# LSD Attwood Cafeteria and Kitchen Renovations

## Addendum No. 1

<b>Project Name:</b>	Attwood Cafeteria and Kitchen Renovations SO-1851	<b>Date:</b>	April 3, 2026
<b>Project Location:</b>	915 Attwood Dr, Lansing, MI 48911	<b>Architect's Project #:</b>	26000747A
<b>Owner/Client:</b>	Lansing School District	<b>Attention:</b>	David Beckering
<b>Issued to:</b>	Beckering Construction	<b>Email:</b>	djb@beckering.com
<b>City/State:</b>	Grand Rapids, MI	<b>Zip:</b>	49548

DRAWING NUMBER:  
**A101**

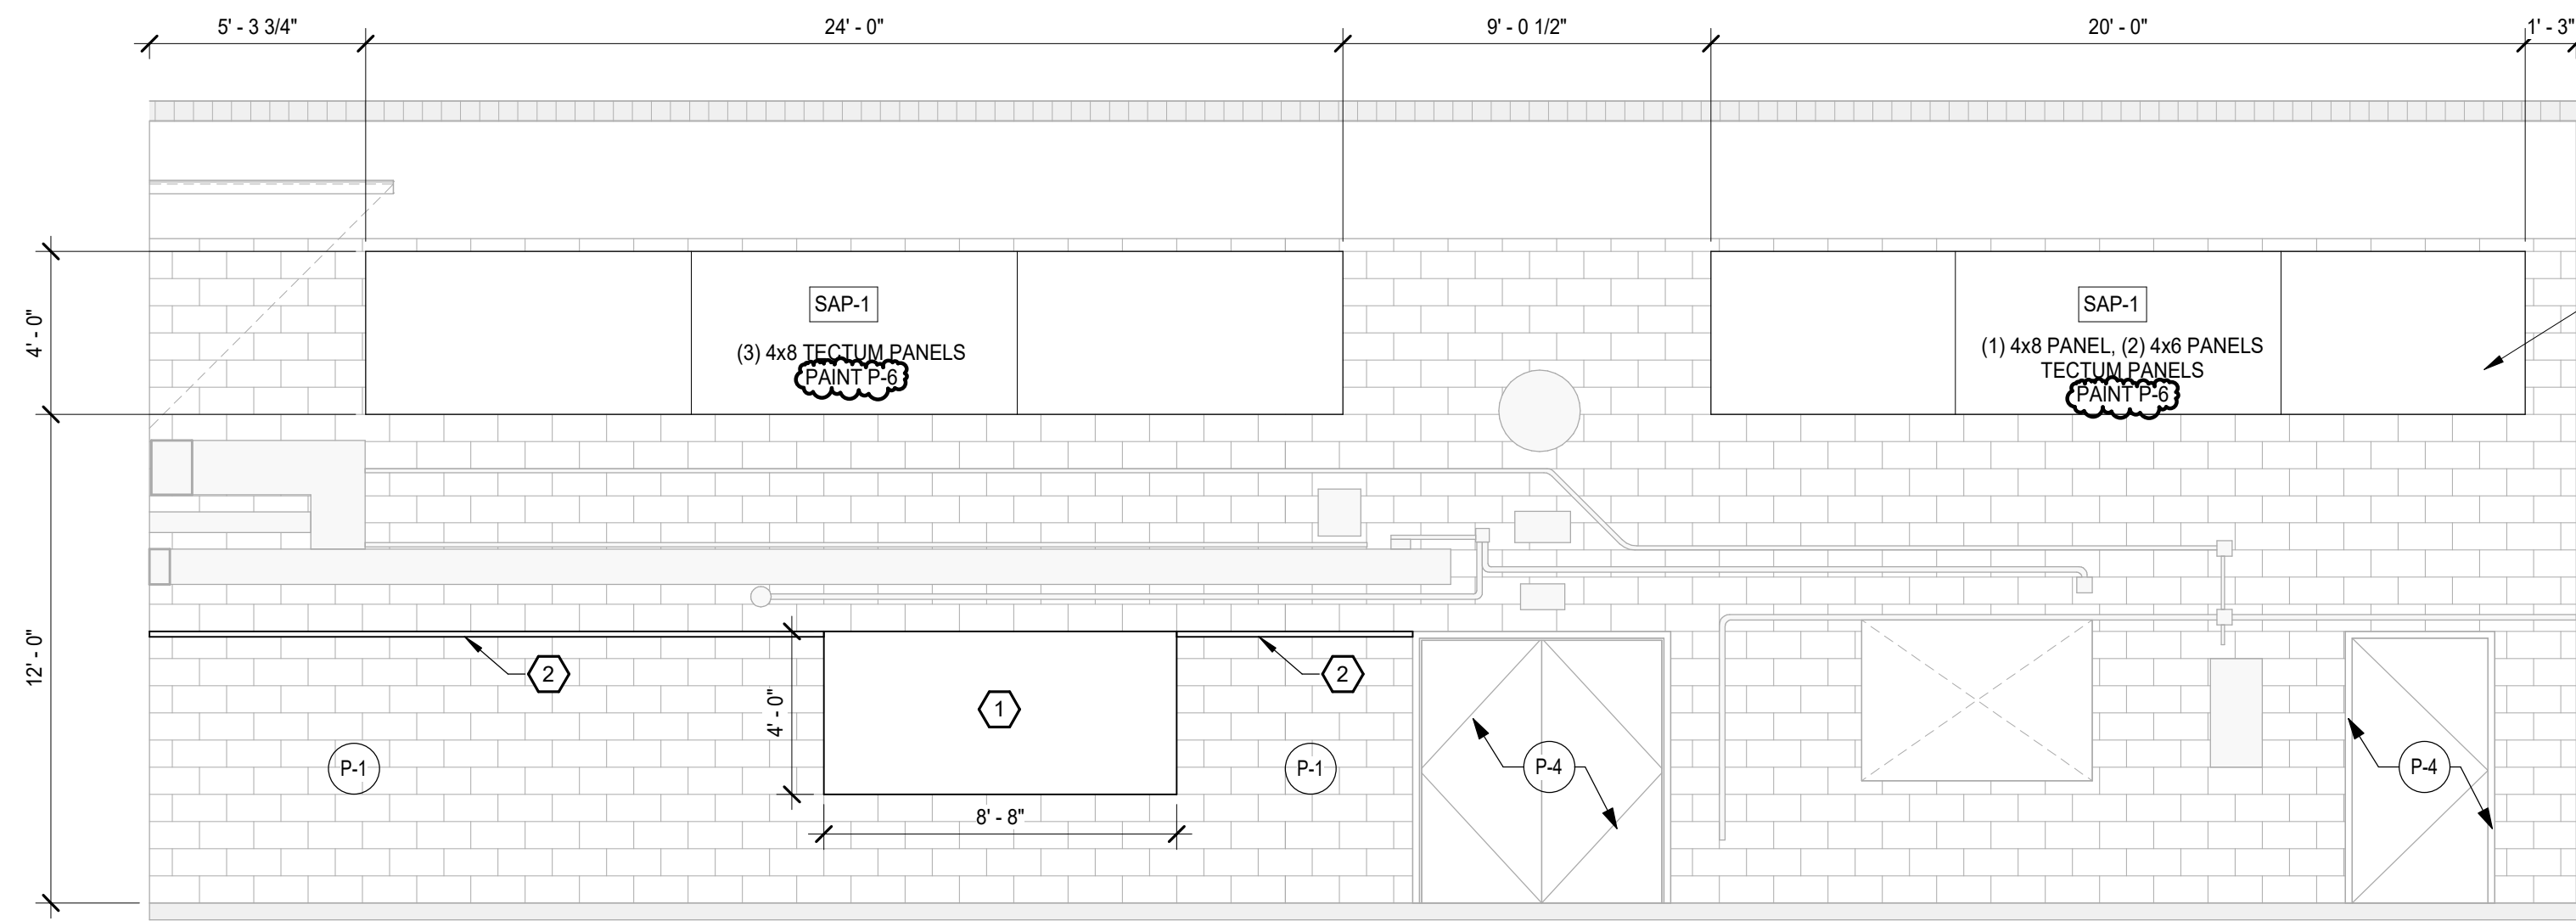
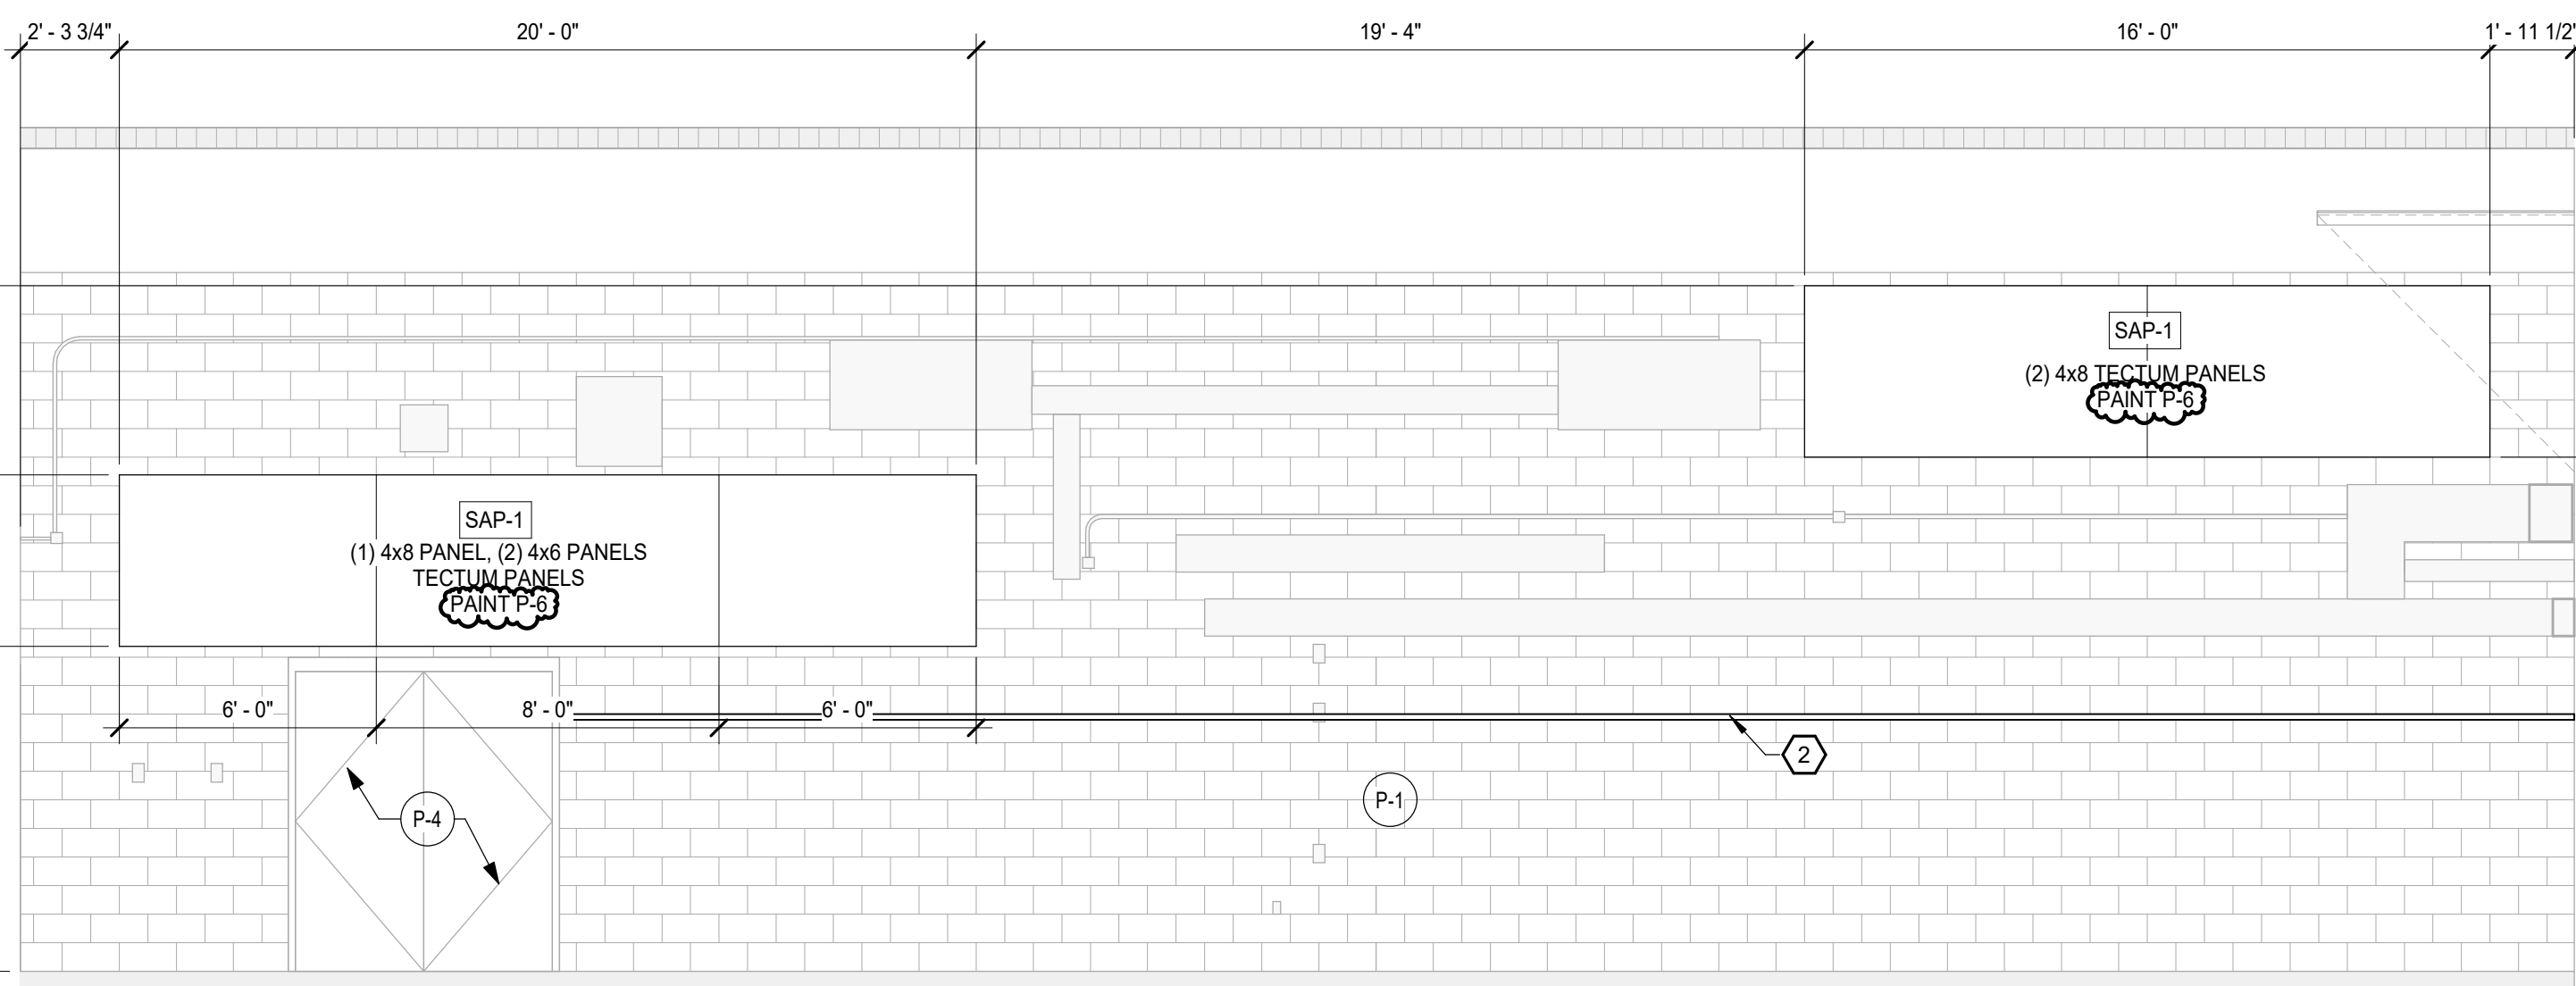
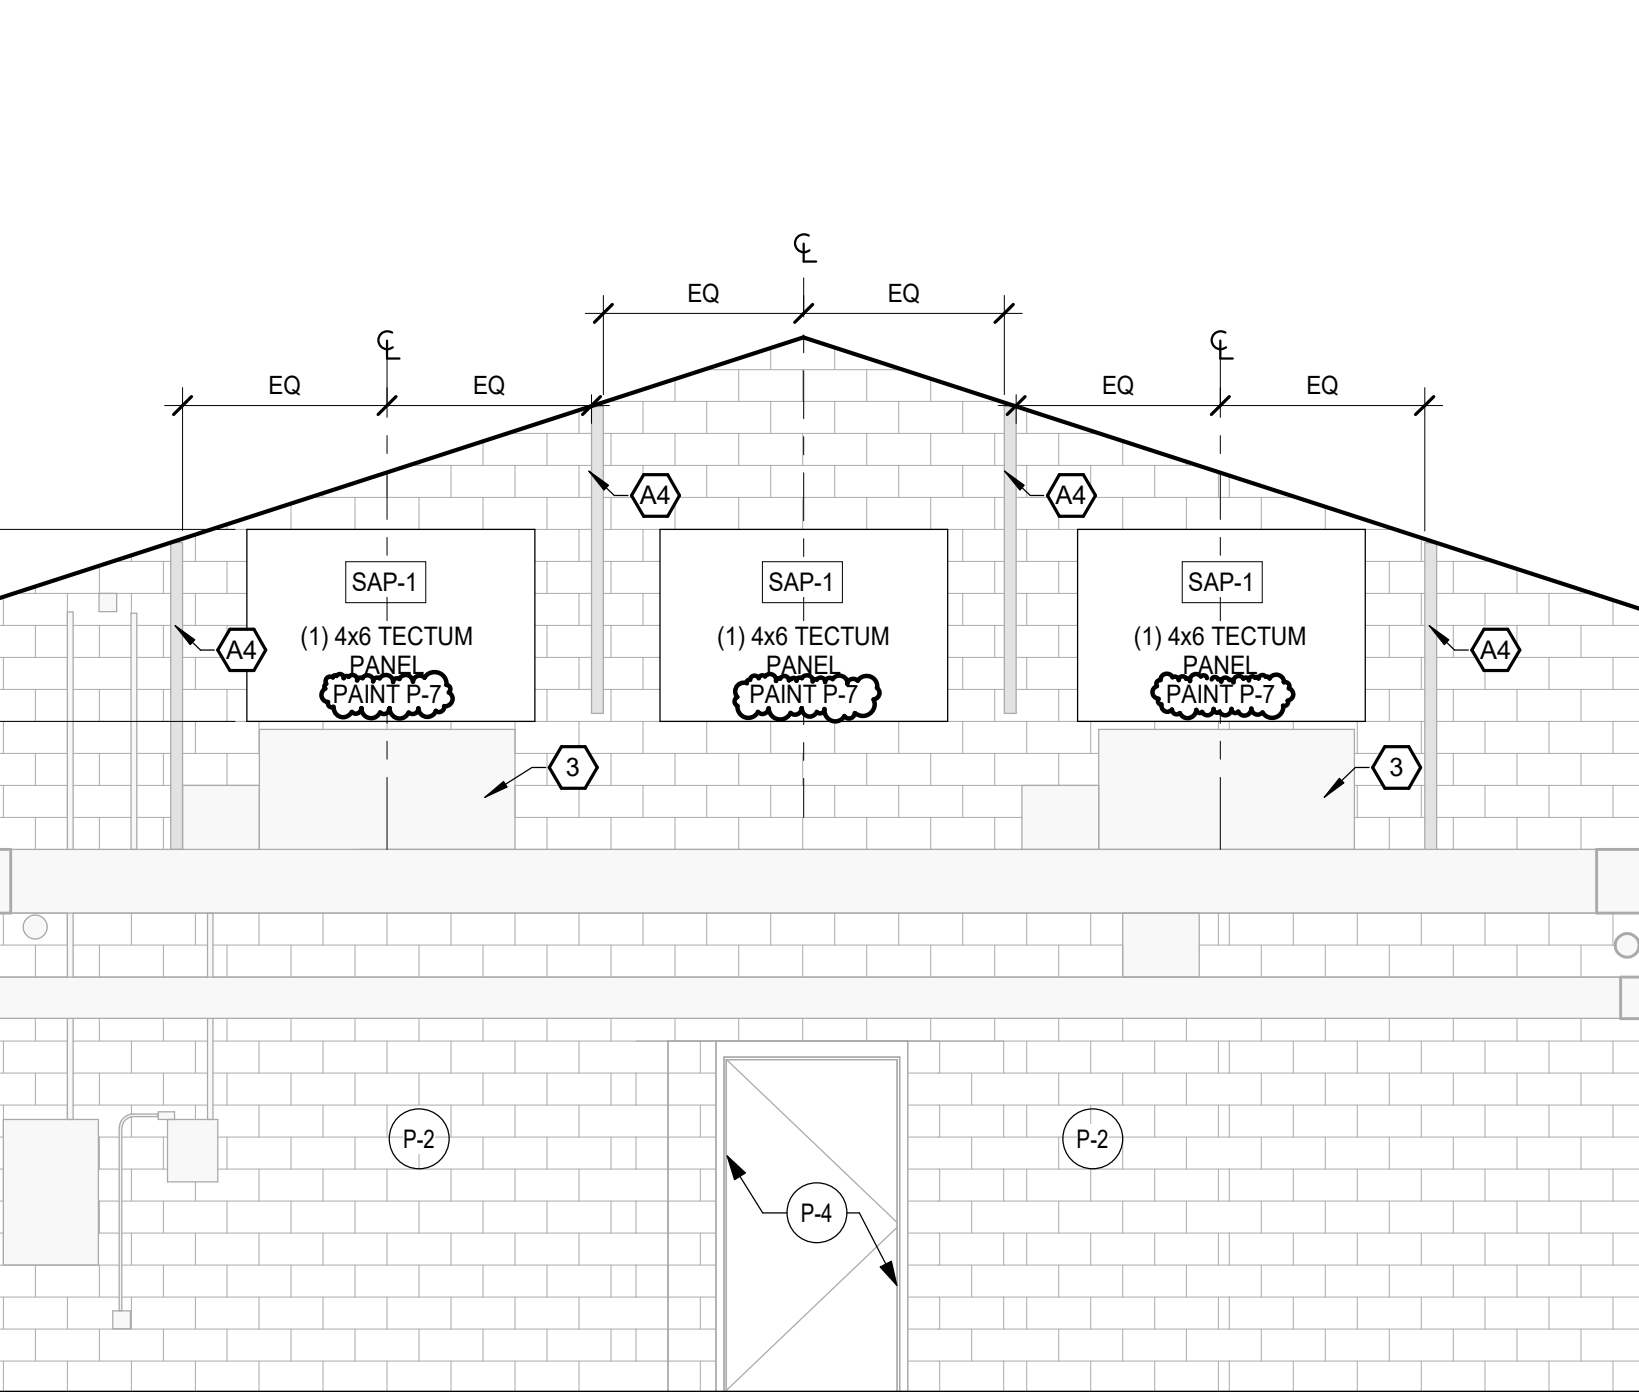
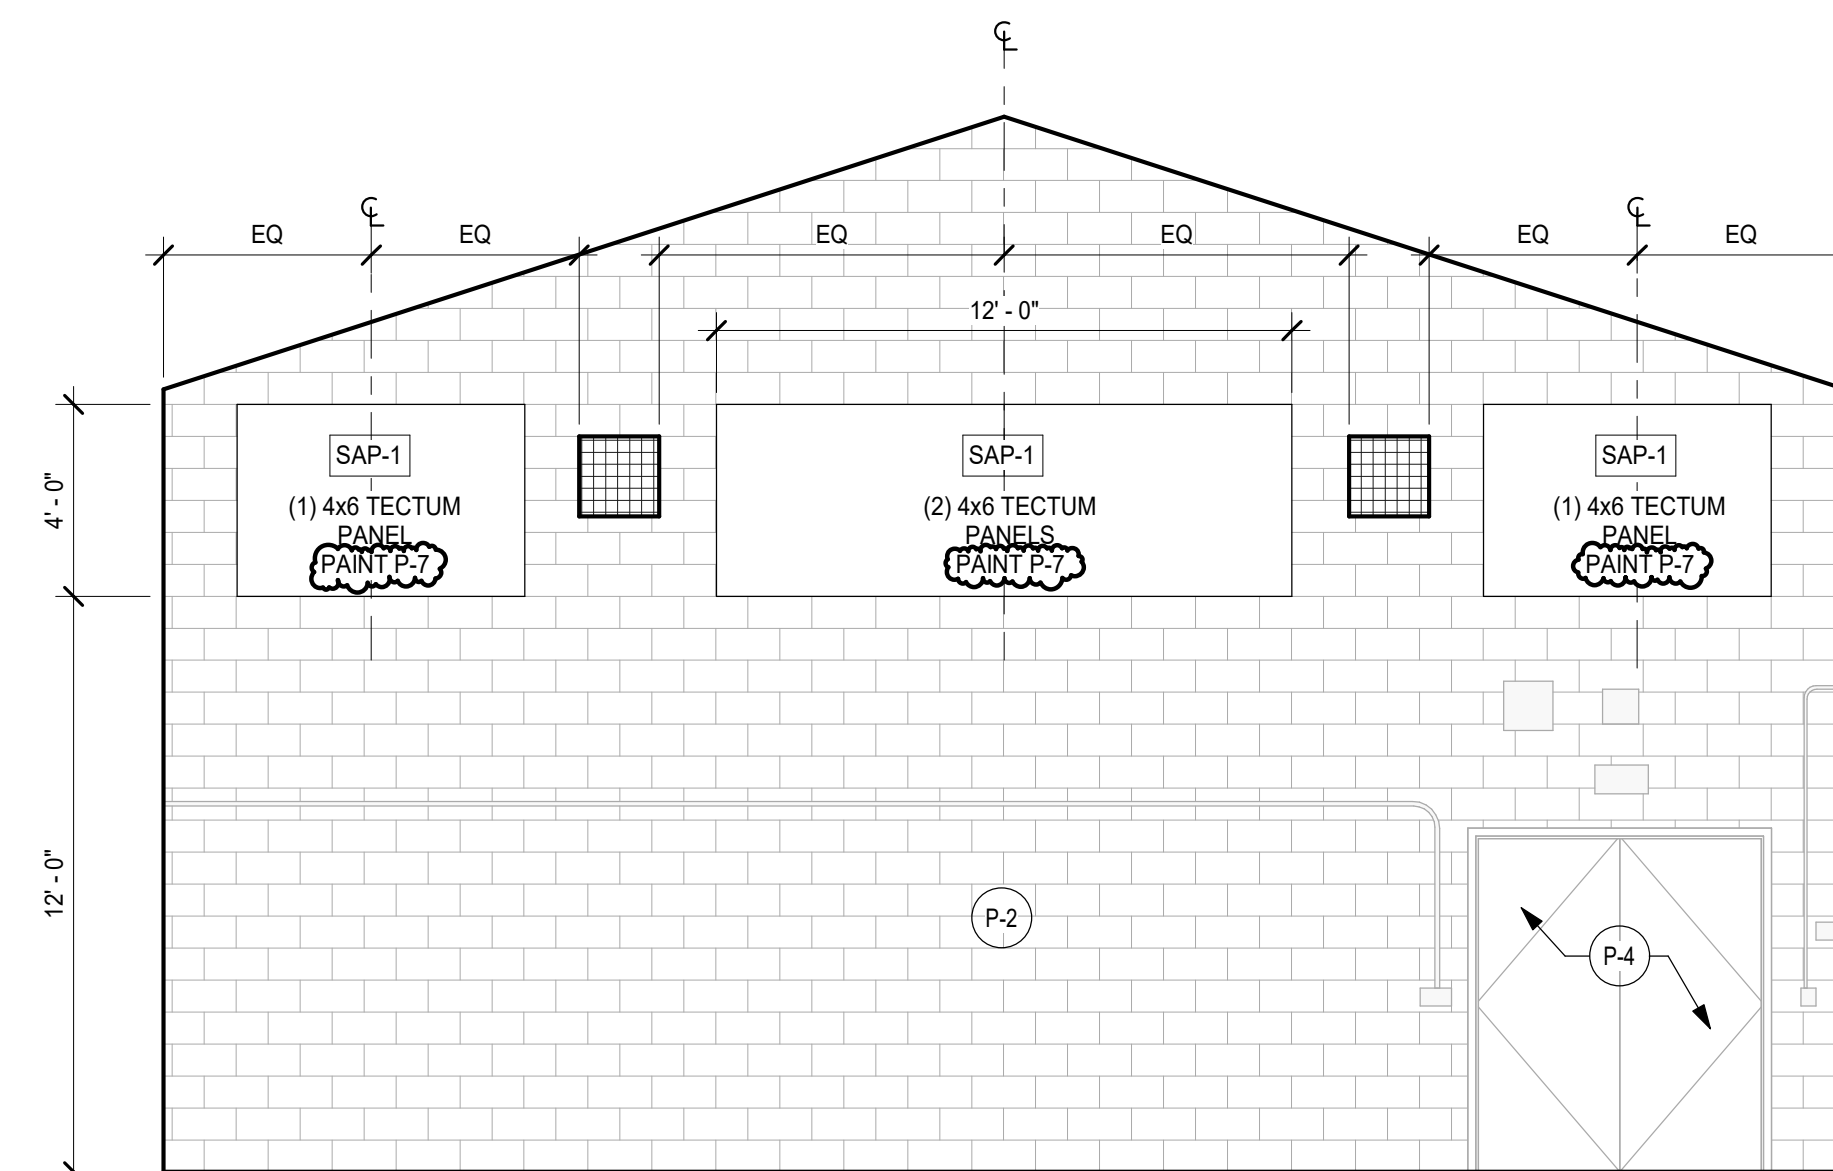
- G000 – COVER Sheet (Reissued)
  - Added electrical sheets to sheet list
- A101 – FIRST FLOOR PLAN AND ELEVATIONS (Reissued)
  - Added paint designation on tectum panels in elevation
- A141 – FIRST FLOOR FINISH PLAN (Reissued)
  - Revised painting specification to include paint system for tectum panels.
  - Revised steel decking paint specification to indicate flat finish.
  - Updated paint basis of design.
  - Revised color of tectum panels.
- E100 – ELECTRICAL SYMBOLS AND SPECIFICATOINS
  - New sheet
- EL101 – FIRST FLOOR PLAN – LIGHTING
  - New sheet
- EL102 – FIRST FLOOR PLAN – EMERGENCY LIGHTING
  - New sheet
- EP101 – FIRST FLOOR PLAN – POWER
  - New sheet
